**AGENDA  
CITY OF CEDAR FALLS, IOWA  
PLANNING AND ZONING COMMISSION MEETING  
WEDNESDAY, OCTOBER 13, 2021  
5:30 PM AT CITY HALL AND VIA VIDEO CONFERENCE**

**TO:** Planning & Zoning Commission  
**FROM:** Chris Sevy, Planner I  
**DATE:** October 6, 2021  
**SUBJECT:** Greenhill Village Car Wash at 1125 Fountains Way

**Greenhill Village Car Wash  
Site Plan Review  
1125 Fountains Way (SP21-012)**

**TO:** Planning and Zoning Commission  
**FROM:** Michelle Pezley, Planner III  
Luke Andreasen, PE, Principal Engineer  
**DATE:** September 30, 2021  
**SUBJECT:** PP21-003 West Fork Crossing Preliminary Plat

PHASING PLAN

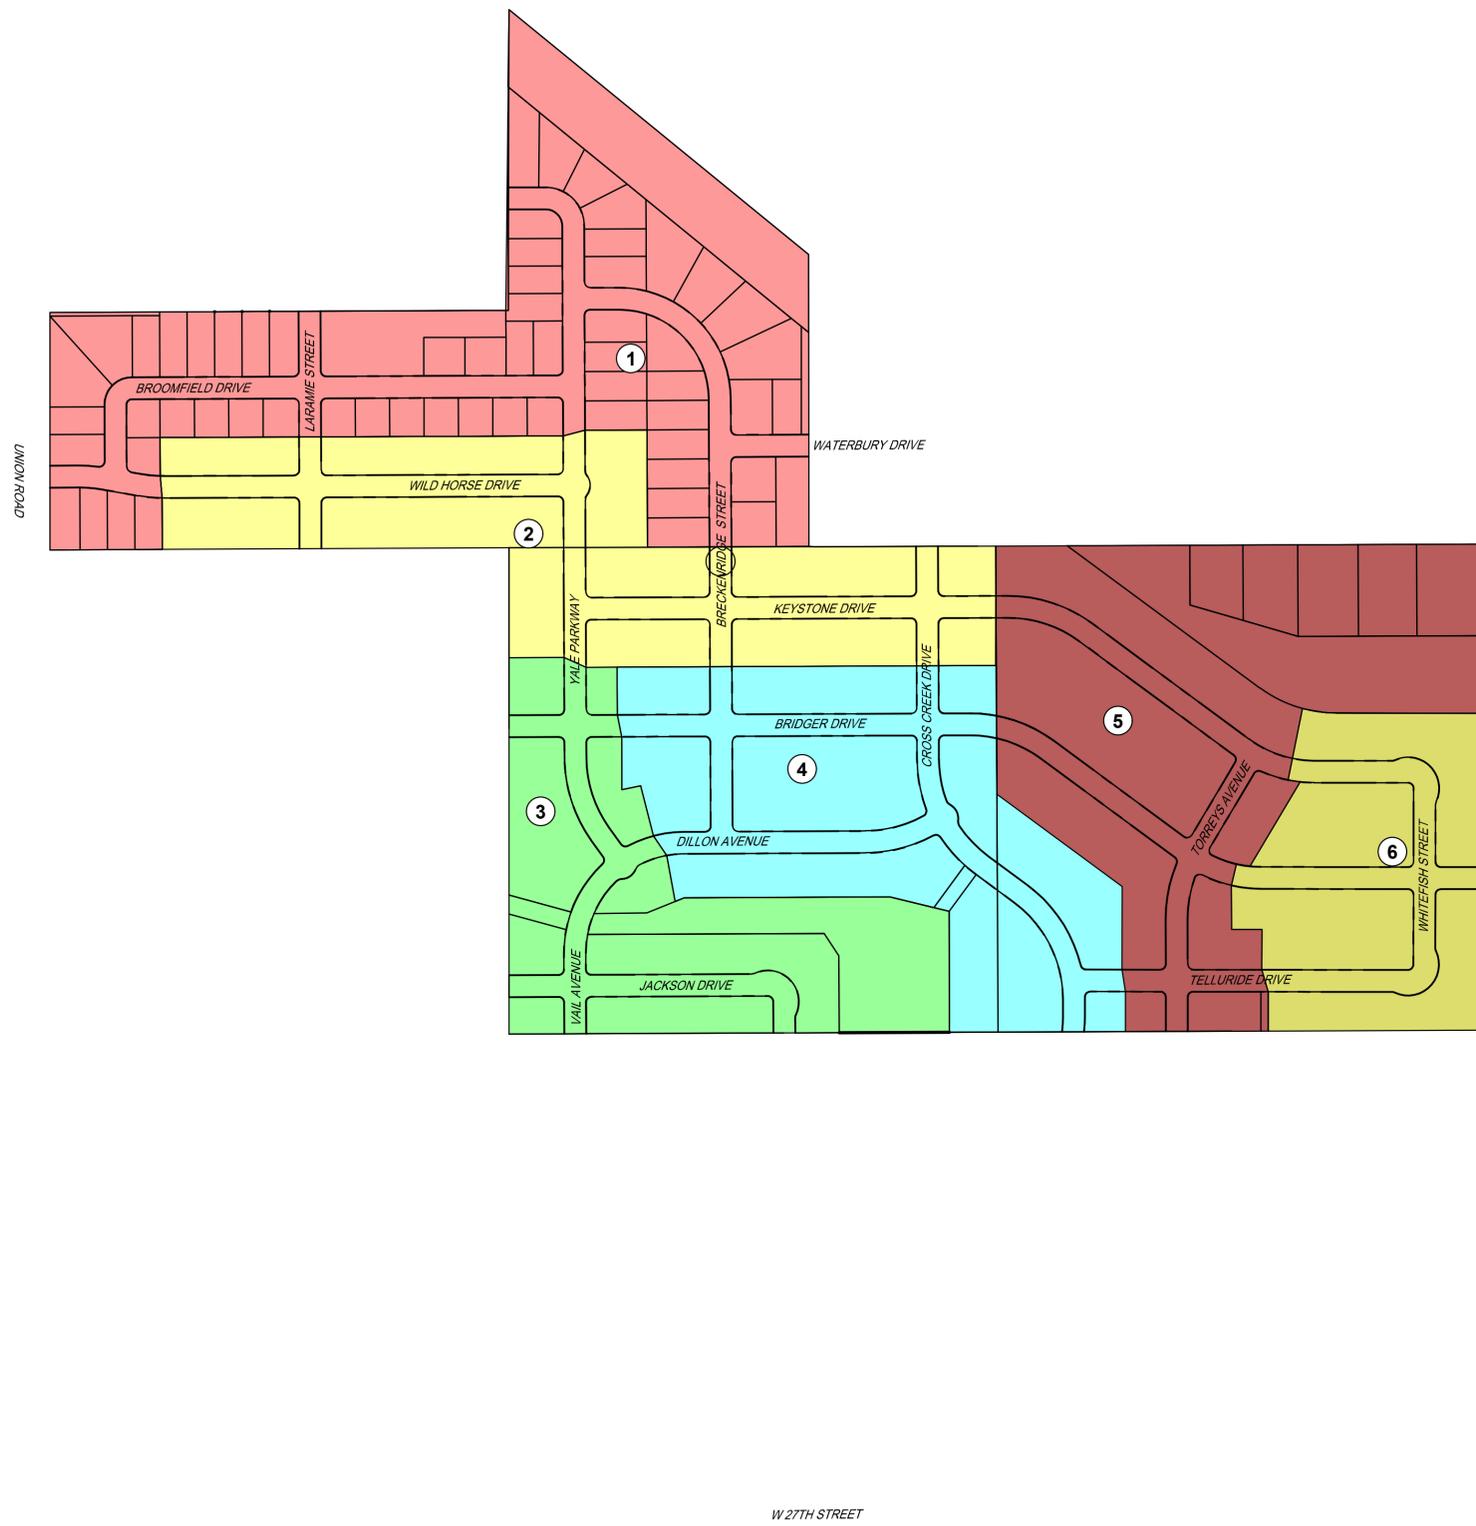
Per the recent amendment to the subdivision code, the applicant is required to submit a phasing plan that shows the order of development with an emphasis on ensuring the timely connection of streets and other infrastructure within the development. The phasing plan will also require multiple, direct routes between neighborhood designations, and ensure that critical street routes are completed first.

The applicant proposes to subdivide the 120 acres within six phases. Staff reviewed the submitted phasing plan with regard to the critical infrastructure needed for the development and the recommendations of the submitted traffic impact letter. Staff outlined three main critical connections regarding the subdivision and for the community: connections running west to east, connections running north to south to W. 27<sup>th</sup> Street, and the neighborhood connection to the Cedar Falls High School. Staff reviewed the traffic impact letter submitted by the applicant and reviewed the proposed street and lot layout and current and future community destinations in the area and determined that the connection between the subdivision and W. 27<sup>th</sup> Street is needed prior to development of the Fourth through Sixth Additions. The applicant has agreed and has noted this on their phasing plan. Staff notes that when the land to the south is rezoned and platted for development, Cross Creek Drive will be required to be extended to W. 27<sup>th</sup> Street as another critical connection to provide adequate traffic circulation through this large neighborhood as it builds out.

The applicant shows in the phasing plan that the First Addition will connect Union Road to Waterbury Drive, which was the anticipated east-west street connection planned with the Lexington Heights subdivision. This will allow Lexington Heights residents a more direct route to important destinations, such as employment centers, schools and shopping areas located to the south and future residents of the new subdivision another route to the north. While staff would have preferred a more direct connection from Waterbury to Union Road with more standard traffic calming measures to slow traffic, the applicant has designed the street layout with a more circuitous route. Since this connection is intended to serve neighborhood traffic circulation needs rather than a regional route, staff finds this to be acceptable. Staff notes that construction traffic

The Second Addition of the development will connect Cross Creek Drive to Union Road. The Third Addition will connect the development to the southern sixty acres owned by the applicant. Staff recommends that the applicant provide a temporary construction access road from W. 27<sup>th</sup> Street with the 3rd Addition. This will provide a route for construction traffic without passing through the completed 1<sup>st</sup> and 2<sup>nd</sup> Additions. (See **Condition 1**). Per the phasing plan, a permanent public street connection to W. 27<sup>th</sup> Street will be required prior to development of the Fourth Addition. (See **Condition 2**).

1. The applicant shall provide a temporary construction access road to 27th Street for the construction of the Third Addition.
2. The applicant shall provide a street connection to 27th Street prior to development of the Fourth Addition.
3. For all phases, the applicant shall limit the construction traffic to Union Road and W. 27<sup>th</sup> Street.
